BUFFALO RUN ACRES SUBDIVISION

CONSTRUCTION DOCUMENTS TAYLOR CITY, WEBER COUNTY, UTAH

BUFFALO RUN ACRES SUBDIVISION
CONSTRUCTION DOCUMENTS

CE4-01

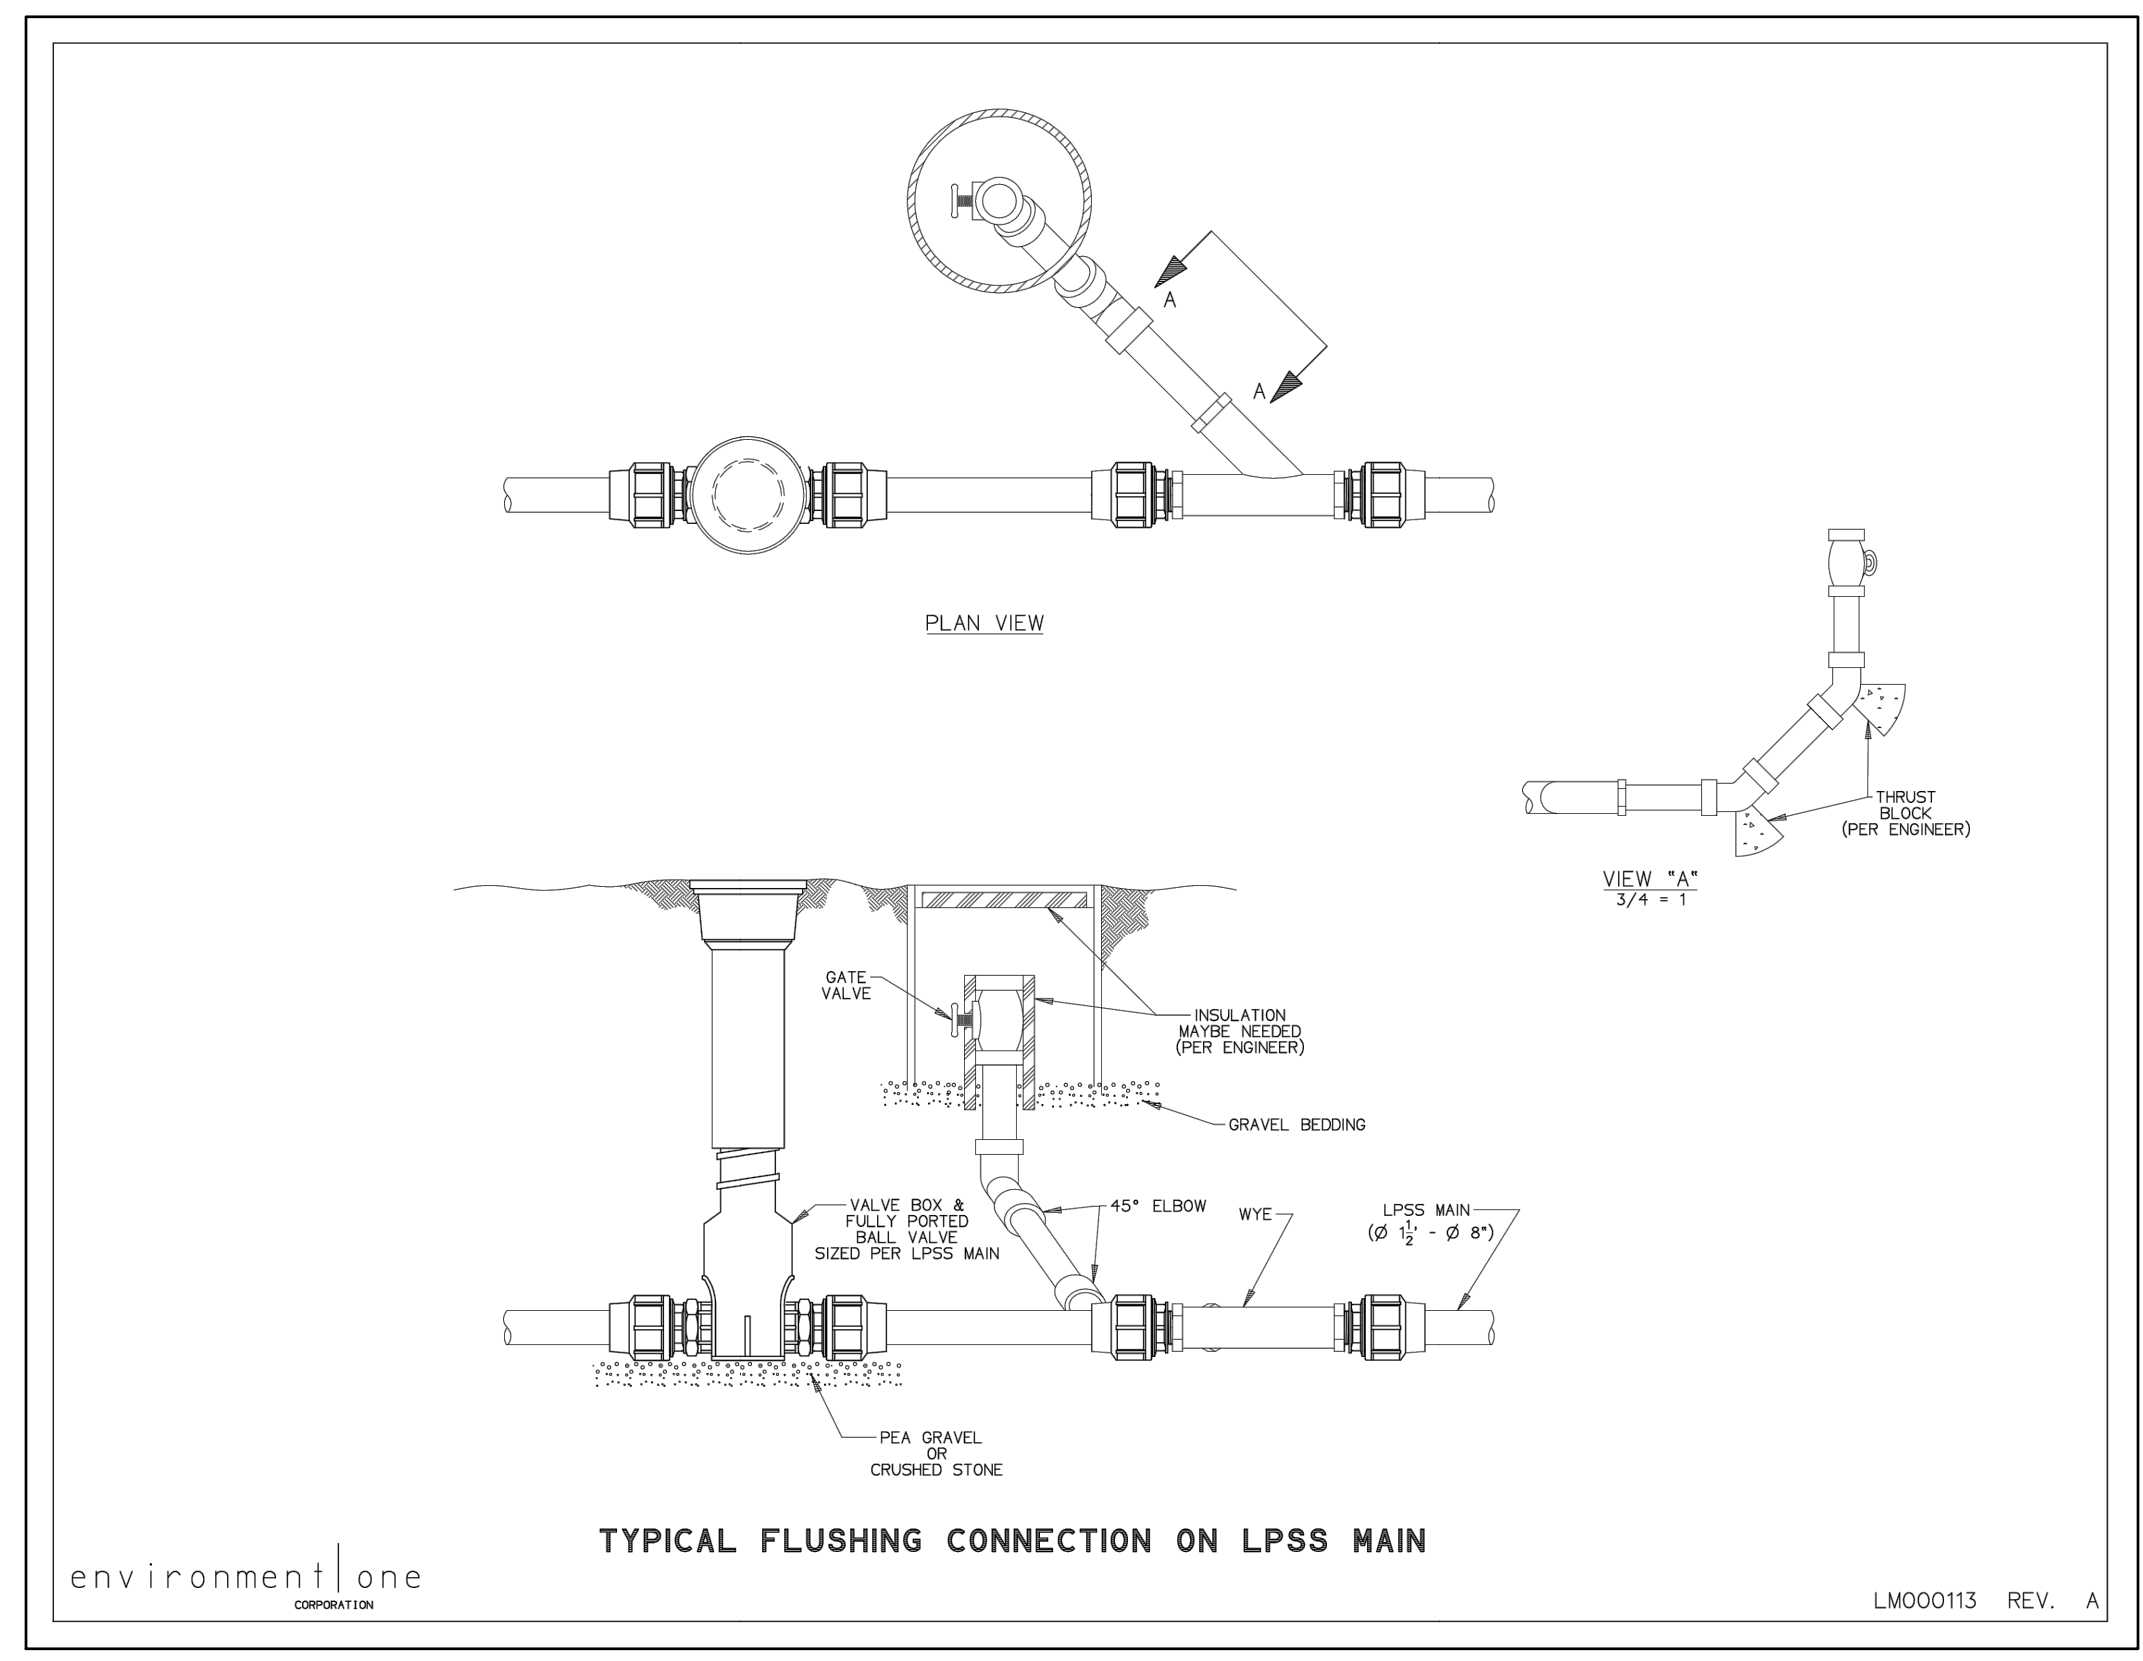
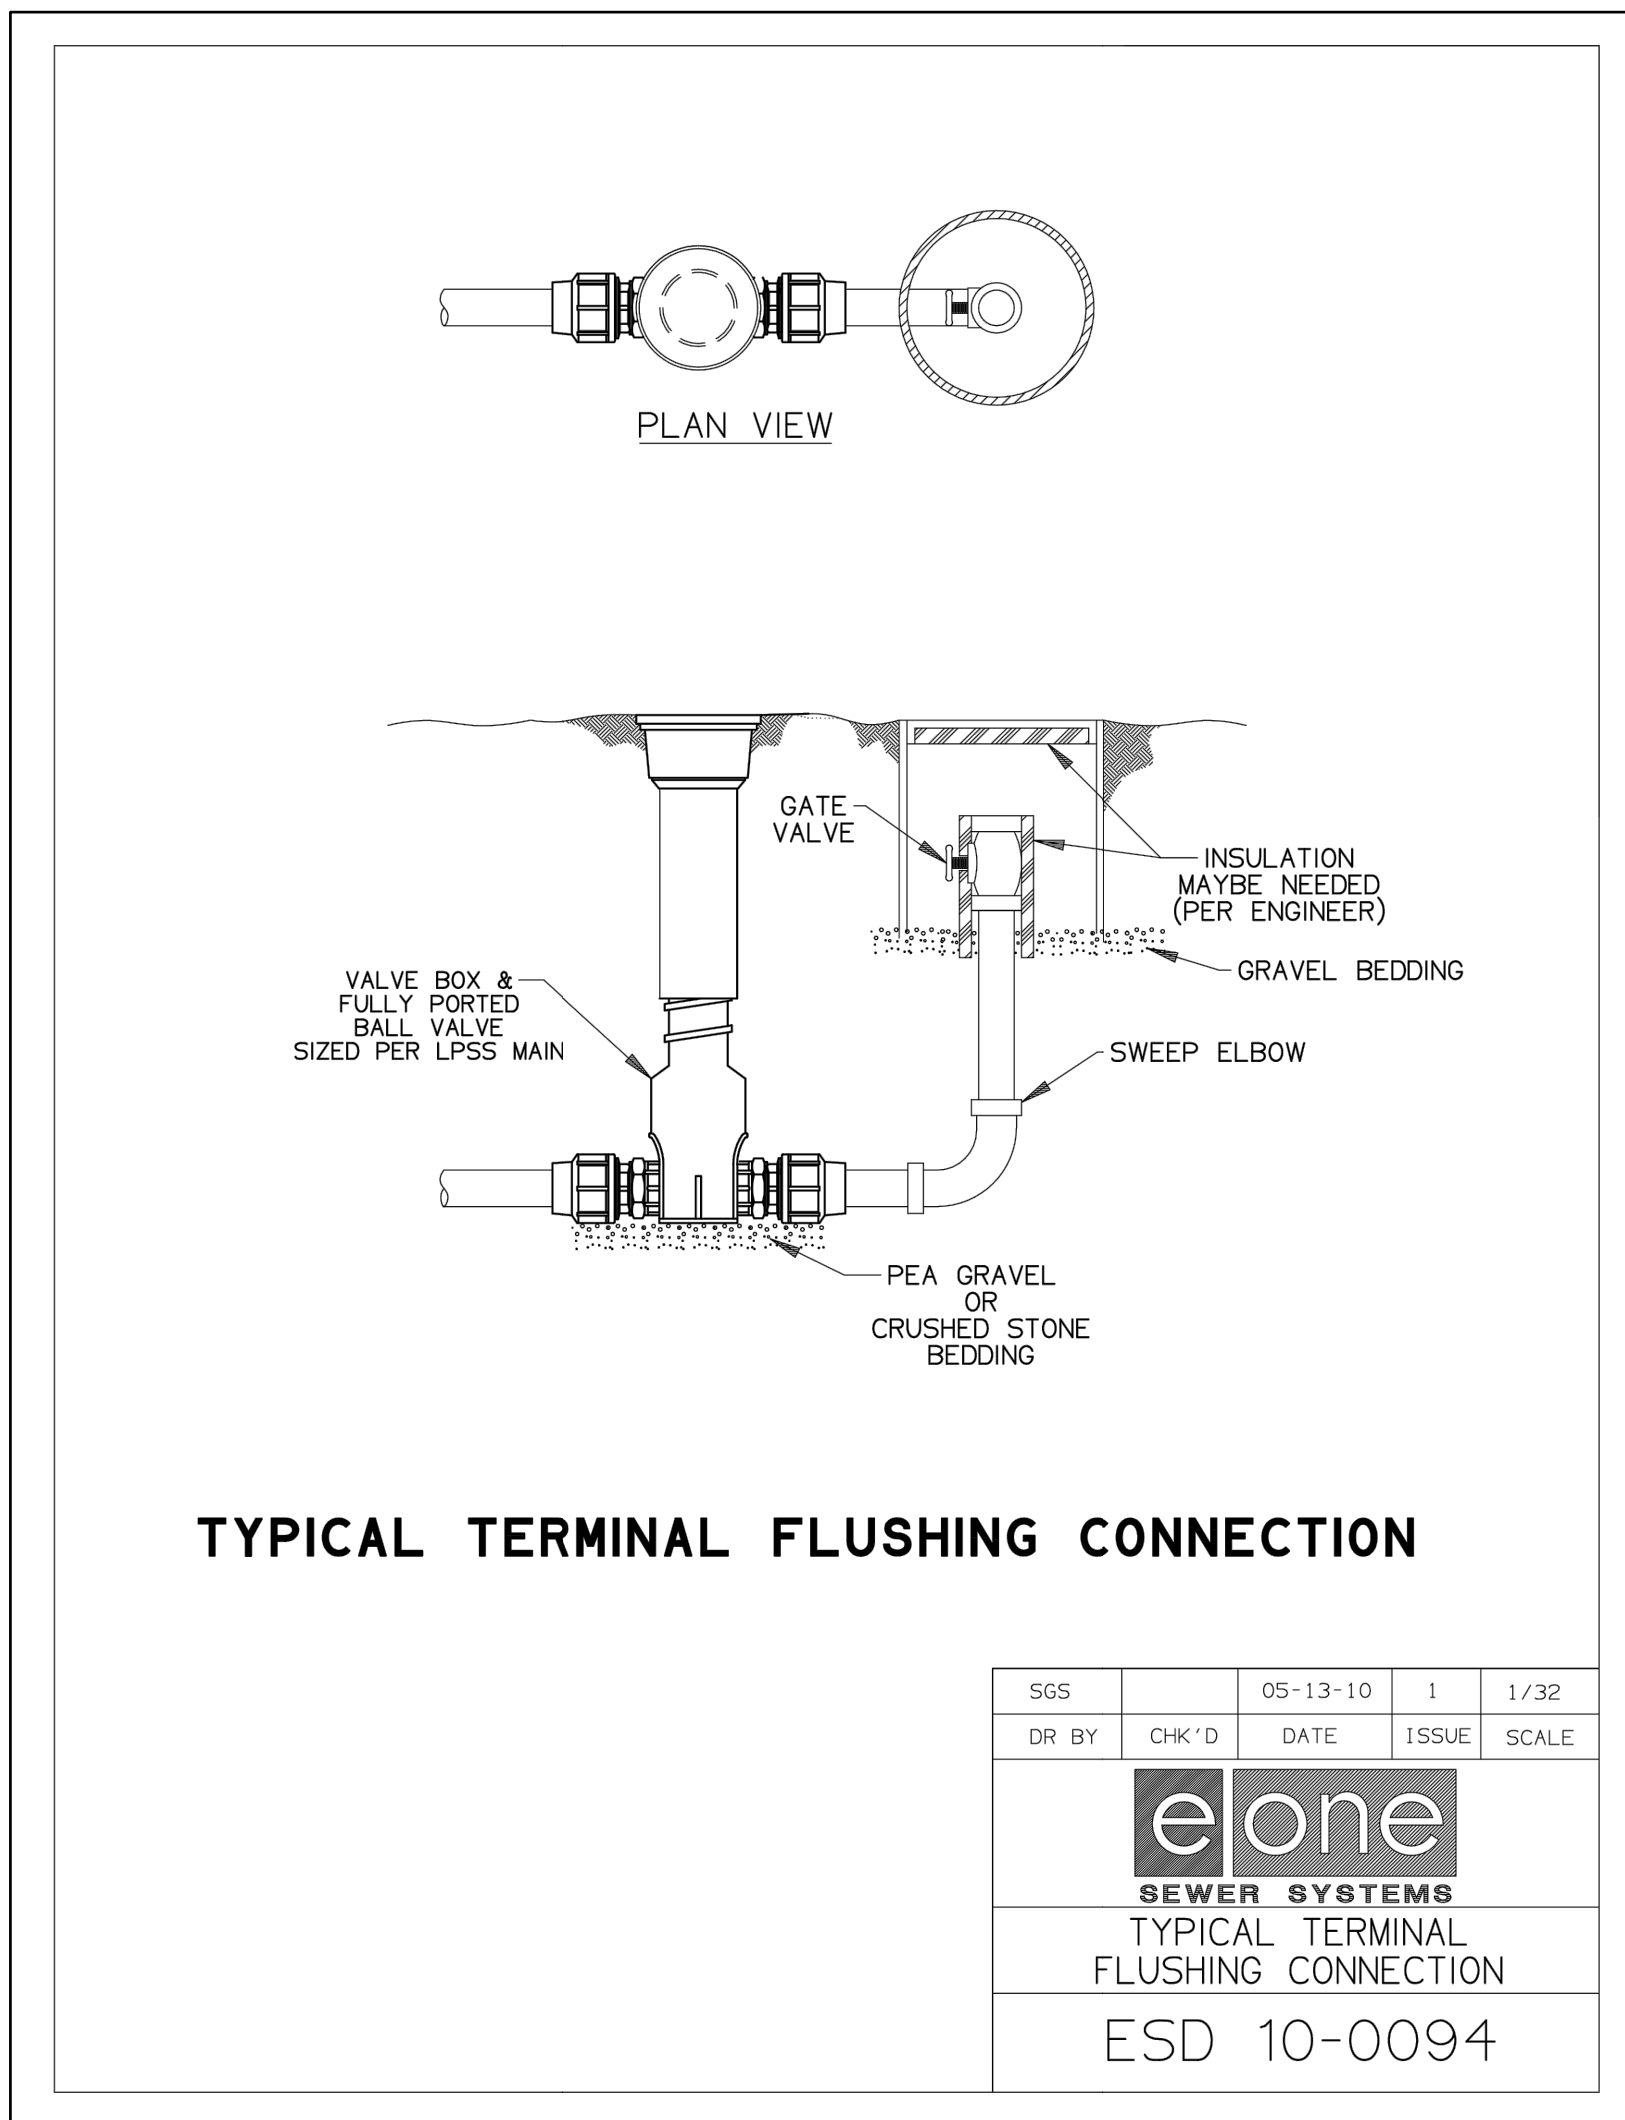
I dont think we need this sheet.
